TO: Mayor & City Council
FROM: Mary Lou DeWitt, Comm. Dev. Zoning Specialist
SUBJECT: **Taco John's Site Plan**
DATE: January 6th, 2021

Re: Taco John's Stormwater Review
WSB Project No. 017245-000

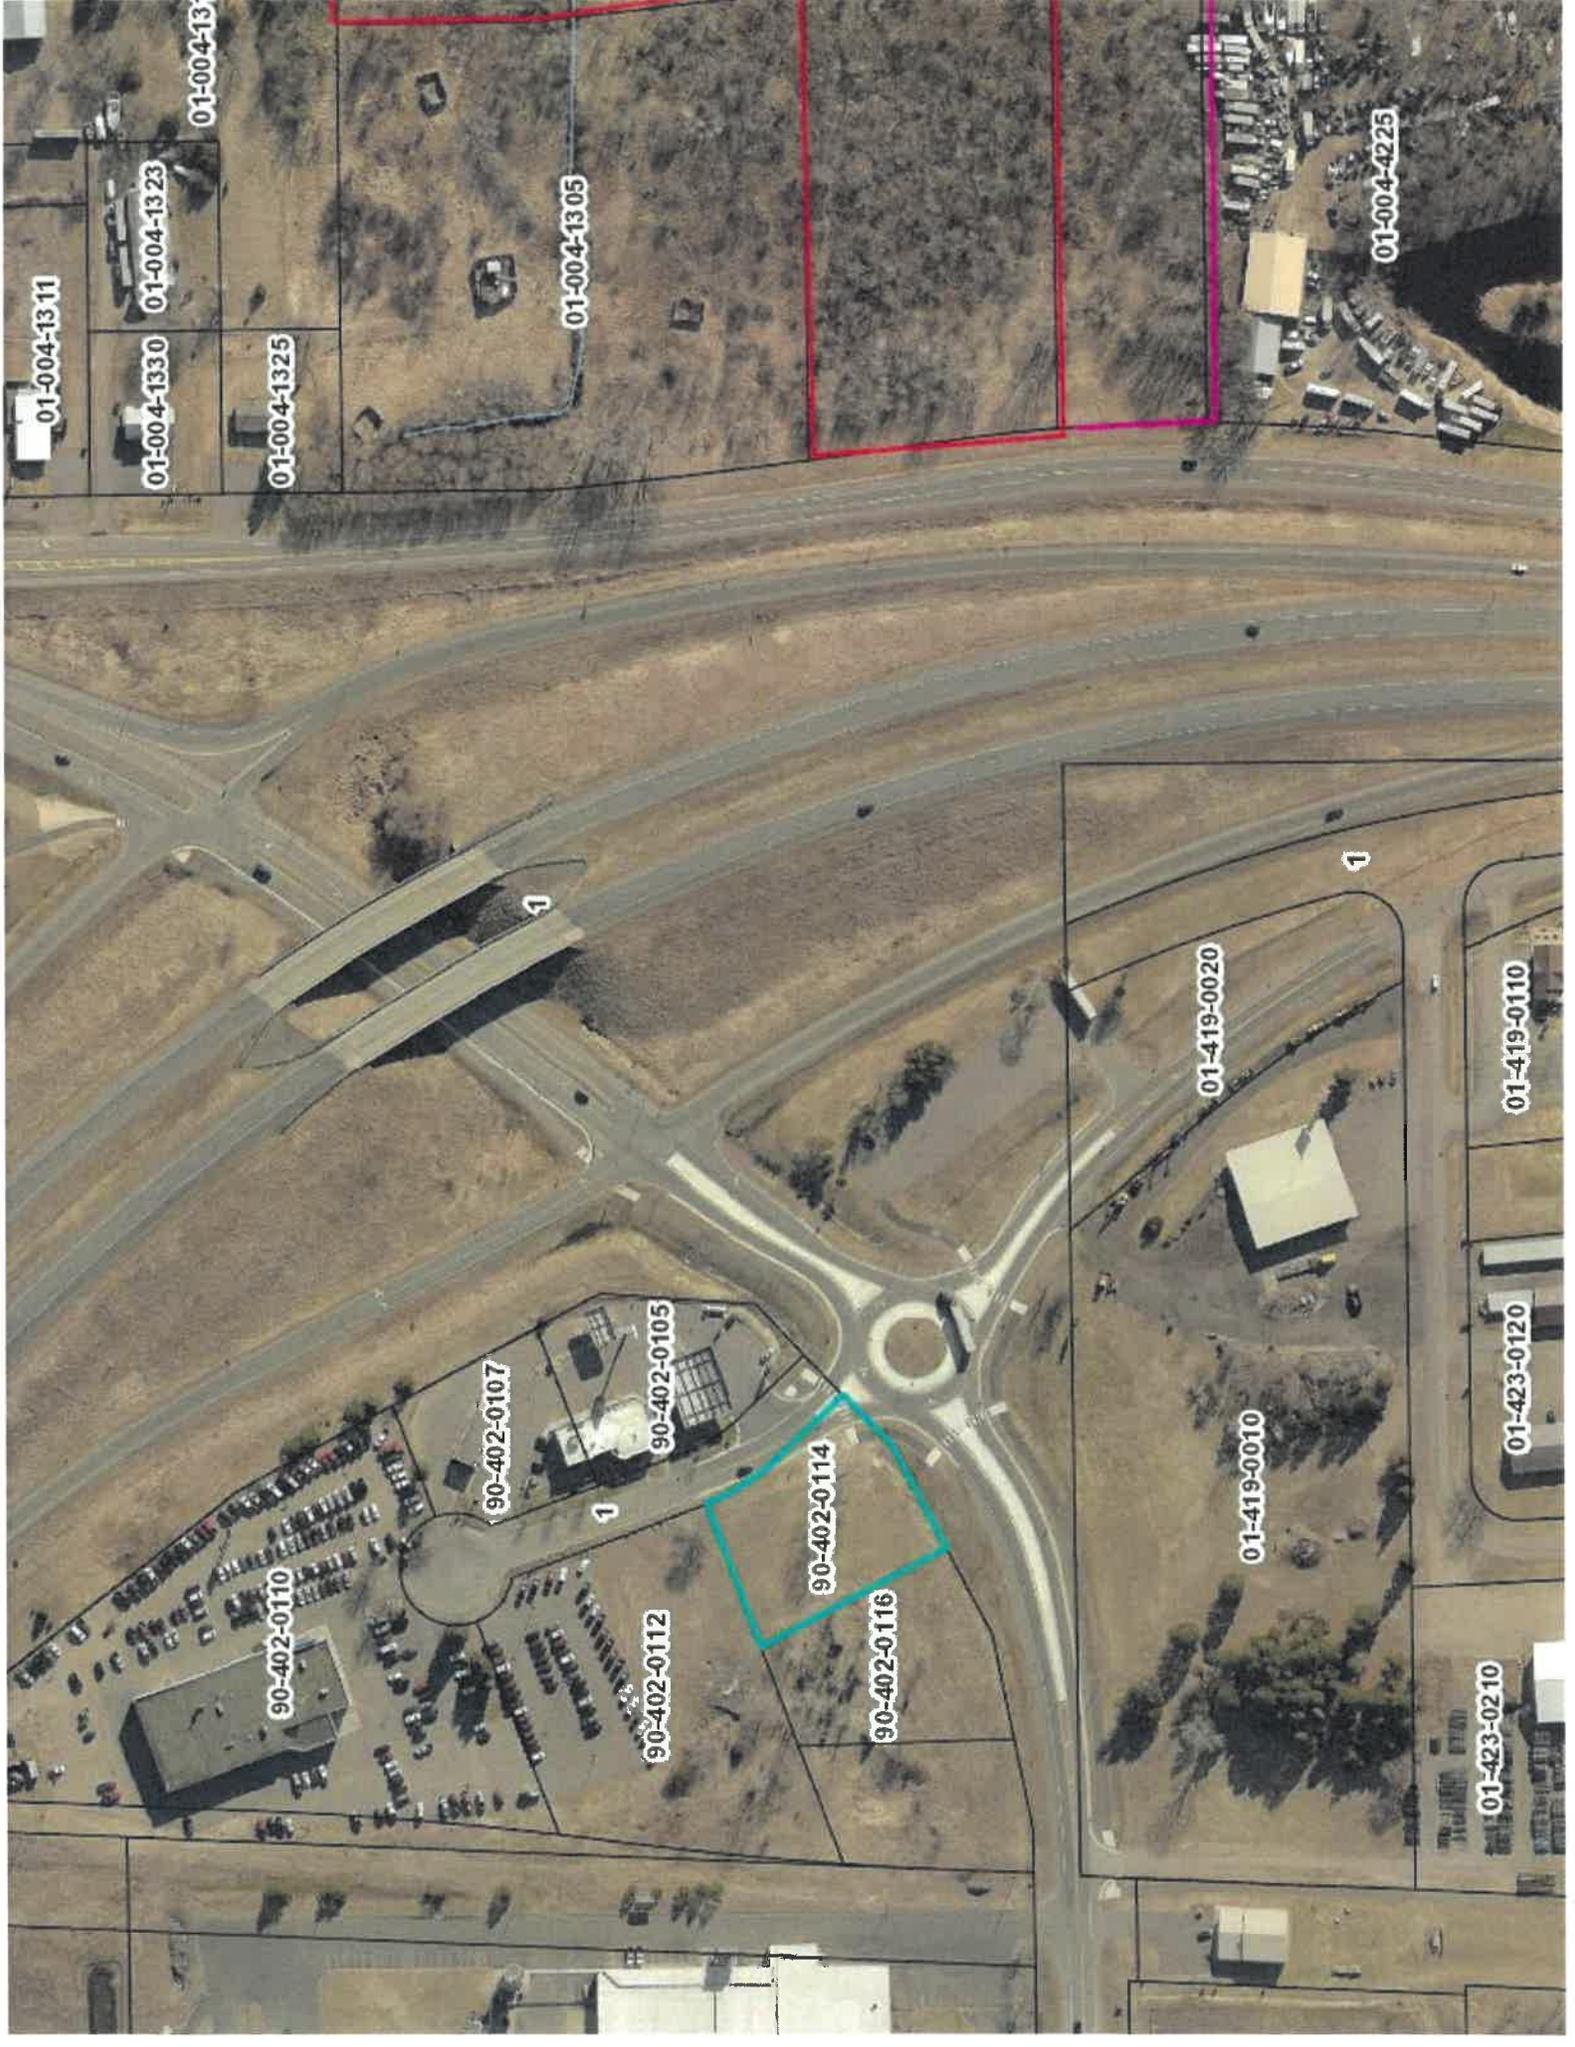
1. The utility plan calls out a 16" PVC storm sewer pipe from CB/MH #3 to CB/MH #4. The storm sewer calculation (HydroCAD model) has a 15" RCP. Clarify which is correct and modify for consistency.

SITE PLAN
 SCALE: 1" = 30.00'
 NORTH

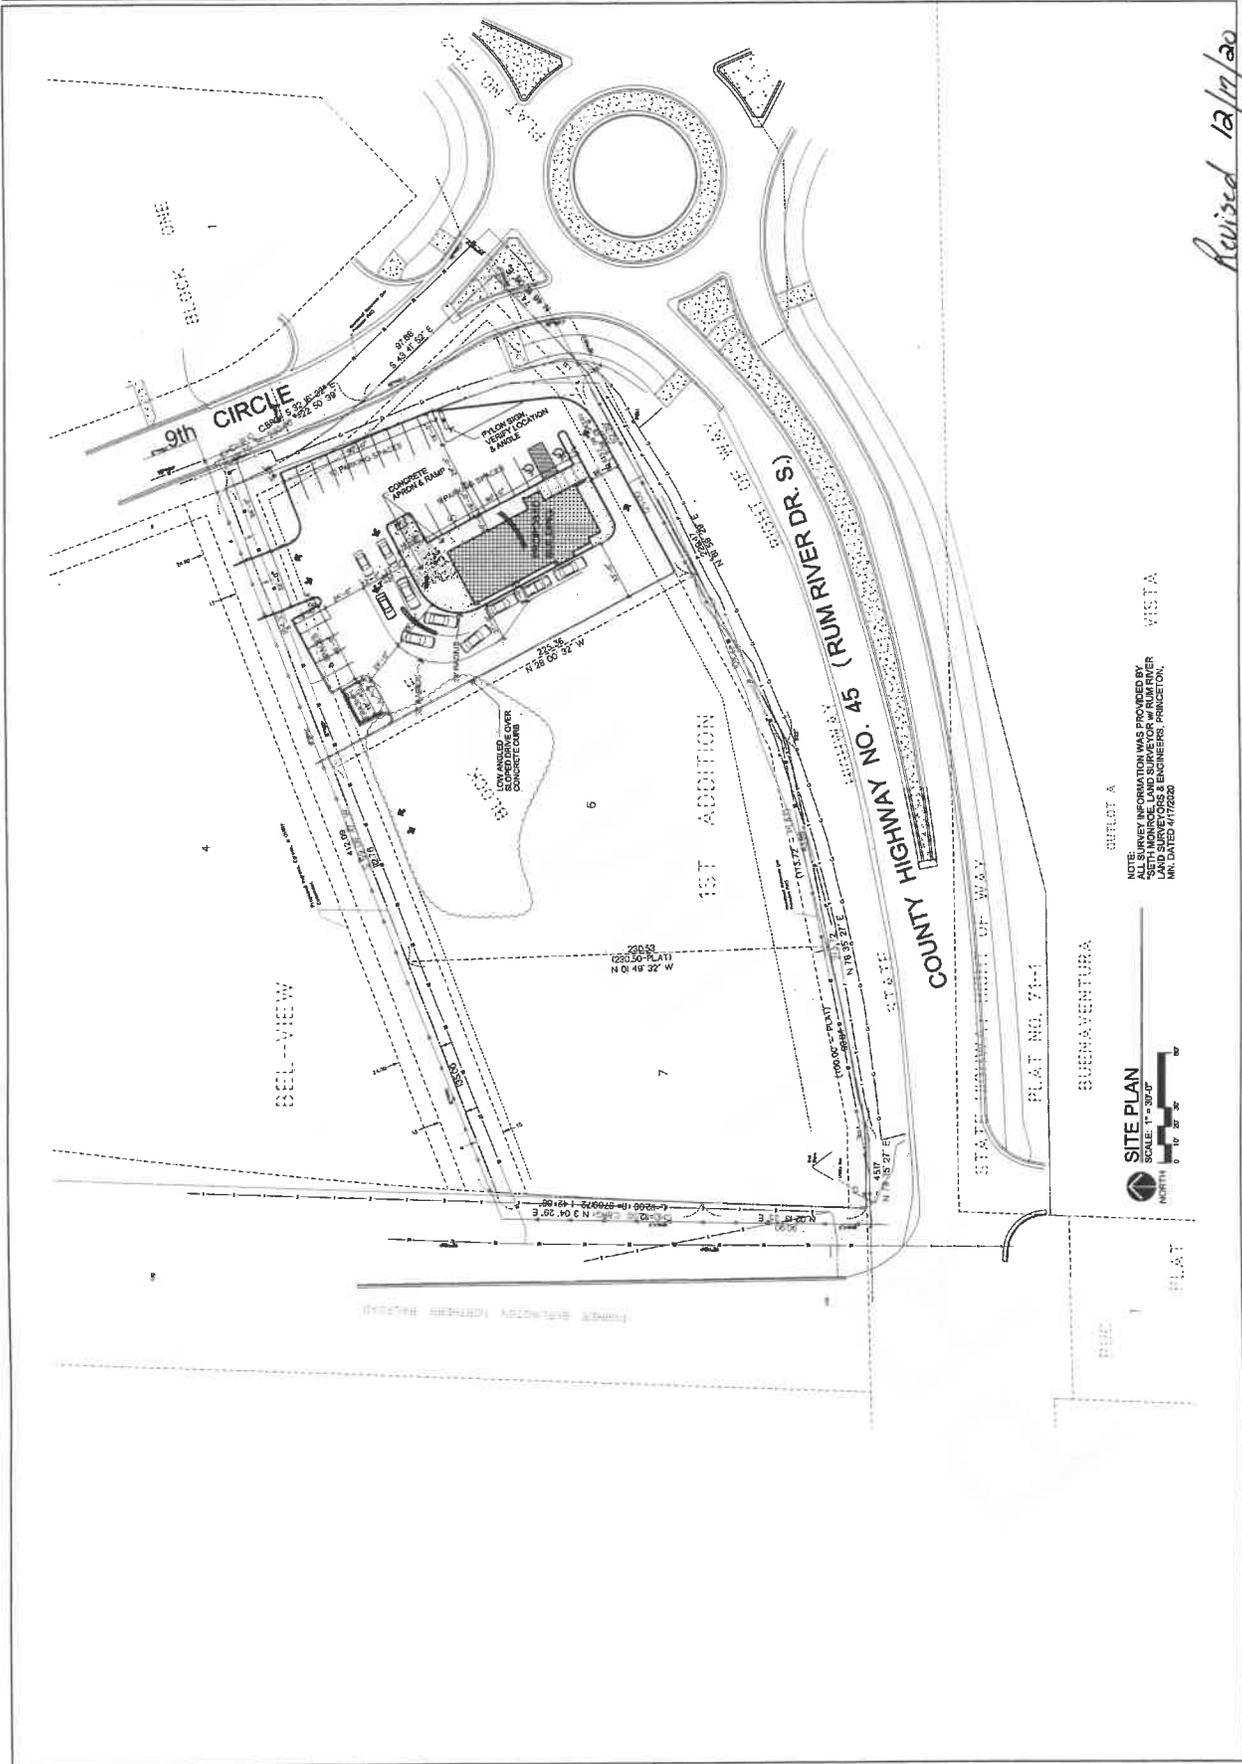
will need to be provided prior to submittal of the building permit. The City Engineer recommended reducing the entrance to the site from the 36' feet down to 30' ft-32' ft from the east. Stacking will be reduced from 52' ft to 46'ft, but this will reduce how close the access from the site to 9th Circle South. There is not much traffic coming from the north and the only competing turns would be from the left turns from Marathon site.

Princeton Public Utilities is okay with the fire hydrant relocated six feet to the south, but in order to do that the water will need to be shut off to Marathon Gas Station and Burger King, and they will work with the contractor to coordinate that effort.

6. Private street access to the site will need easement clarification and maintenance agreement to service Lot 6 and Lot 7.
7. The City Engineer recommends reducing the entrance to the site from the 36' feet down to 30' feet-32' feet from the east.

8. Fire hydrant relocation will need to be coordinated with Public Utilities and Contractor for the shut off of water to Marathon Gas Station and Burger King.
